CHANGE NOTIFICATION

PCN#: 110711

Subject: Notification of Internal Die change for LTM2881

Figure 1. Error Example: DI Transitions Occur at Intervals That Are Multiples of $1.2\mu\text{s}$, Causing the Y and Z Outputs to Be Delayed By $1.2\mu\text{s}$

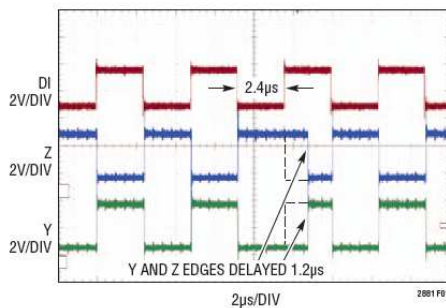
Some LTM[®]2881 devices have an internal timing race condition that can cause signals passing through the isolation barrier to be delayed or inverted for up to one refresh period of $1.2\mu\text{s} \pm 0.15\mu\text{s}$. This condition can occur if there is a specific narrow alignment of signal transitions and only if this is coincident with the rising edge of an internal asynchronous clock. Because of the tight alignment tolerance requirements and asynchronous nature of this event, this error is very infrequent. Workarounds are described in the following section. The LTM2881 is being revised to correct this issue. Contact Linear Technology Corporation regarding availability.

An example of an error is shown in Figure 1.

Most LTM2881 devices will never exhibit this behavior. However, to eliminate these errors in all devices, follow these guidelines:

1. Switch DI so that transitions occur at intervals less than $1.05\mu\text{s}$.
2. Do not change DE or TE $20\text{ns} \pm 5\text{ns}$ before a transition on DI.

- A. Operate DI avoiding high and low times that are multiples of $1.2\mu\text{s} \pm 0.15\mu\text{s}$.
- B. Do not change DE or TE $1.2\mu\text{s} \pm 0.15\mu\text{s}$, or multiples of this, before any transition on DI.

3. Operate differential signal (A-B) avoiding high and low times that are multiples of $1.2\mu\text{s} \pm 0.15\mu\text{s}$.

4. Maintain static input on pin D_{IN} when (A-B) is switching.

- C. Do not change D_{IN} $40\text{ns} \pm 20\text{ns}$ after a transition on (A-B).
- D. Do not change D_{IN} $1.2\mu\text{s} \pm 0.25\mu\text{s}$, or multiples of this, before any transition on (A-B).
